**ADDENDUM 2
KODIAK ISLAND BOROUGH
North Star Elementary Siding & Window Upgrade
Kodiak, AK**

December 9, 2021

**Kodiak Island Borough School District
North Star Elementary School
Siding & Window Upgrade
Kodiak, Alaska**

A002

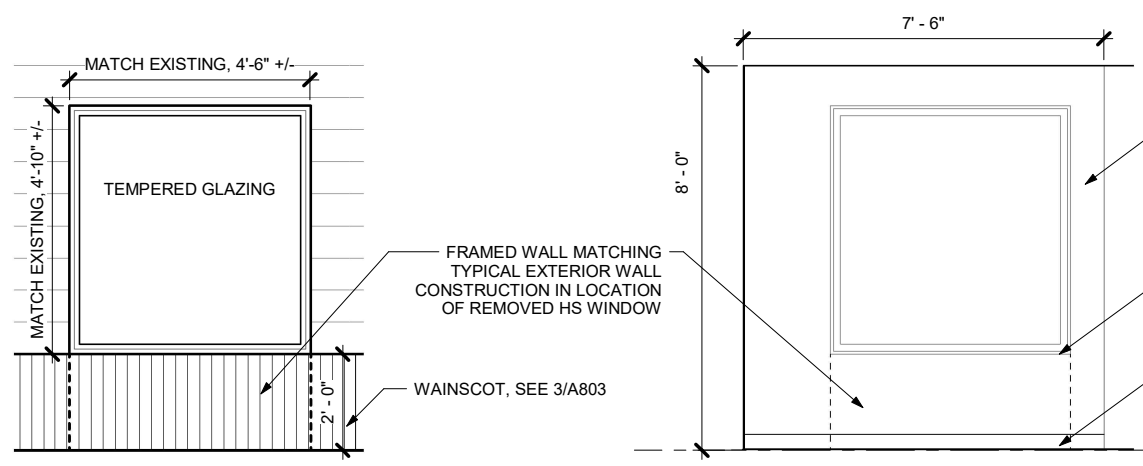
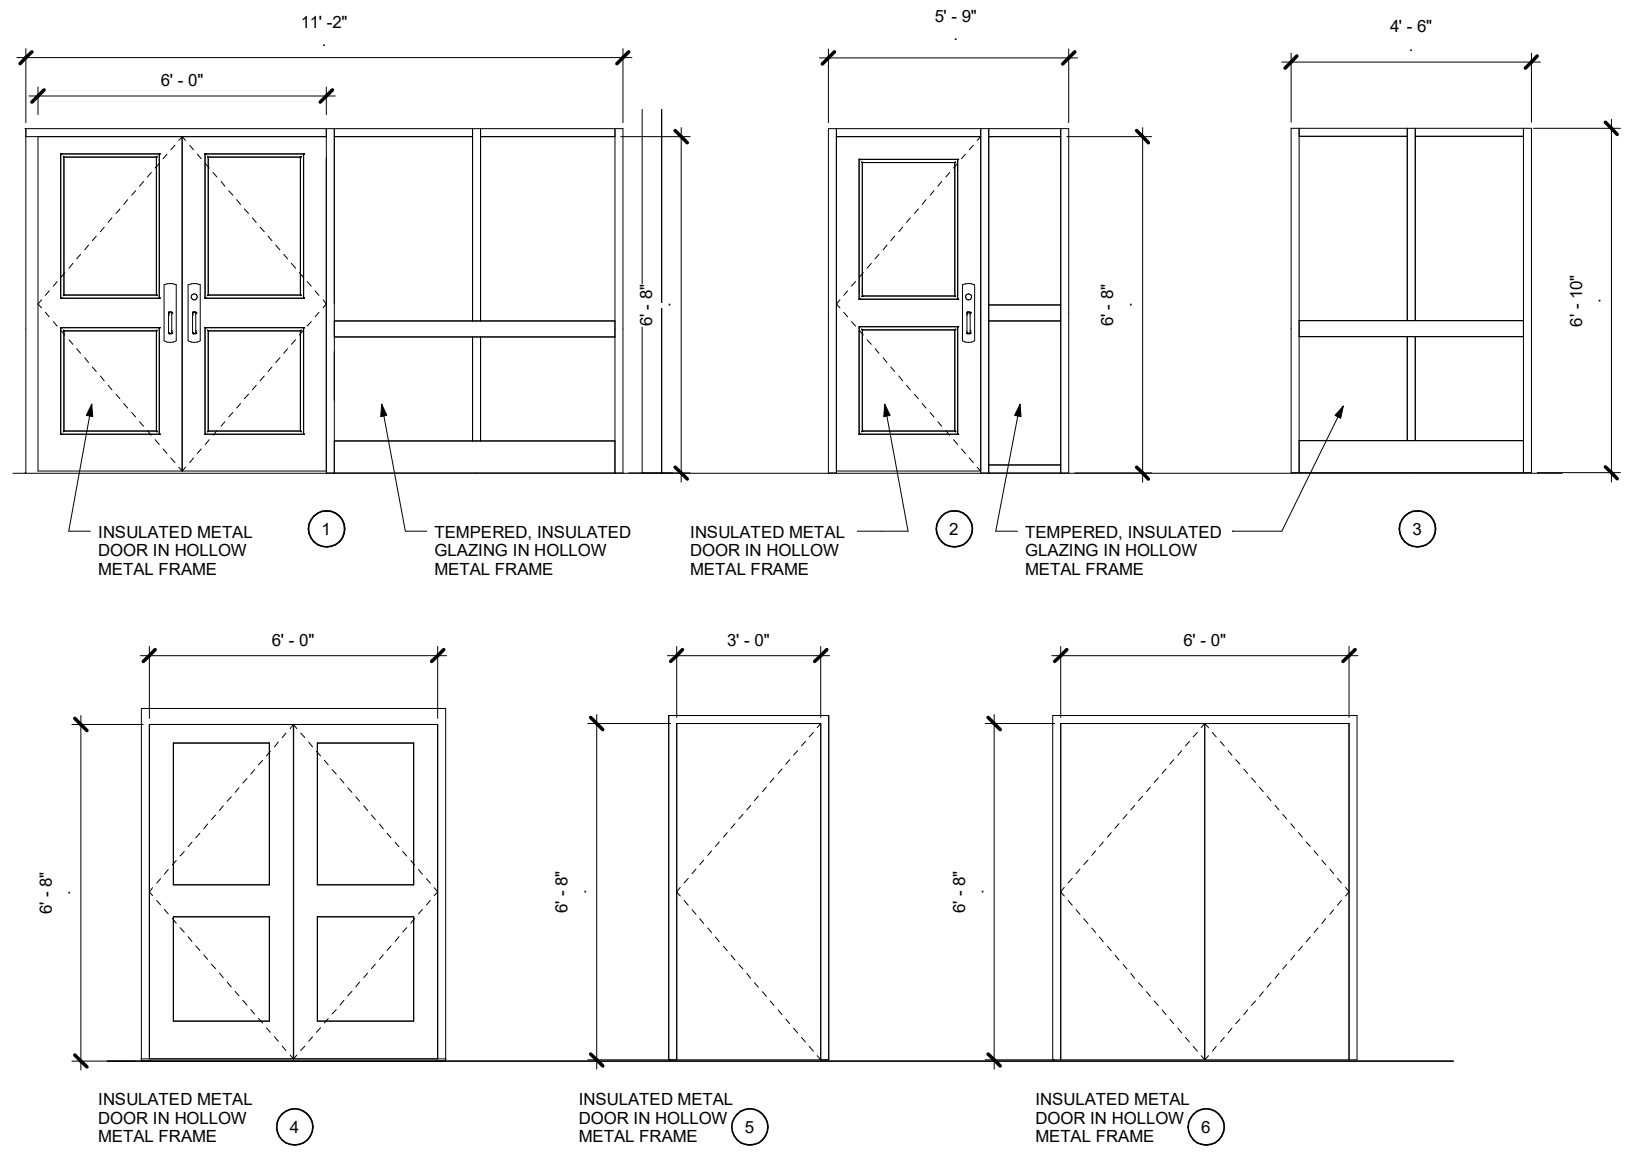
Sheet A002: Replace sheet with revised sheet dated 12/9/21 and attached to this addendum. Revised sheet has additional interior finish details for infill areas.
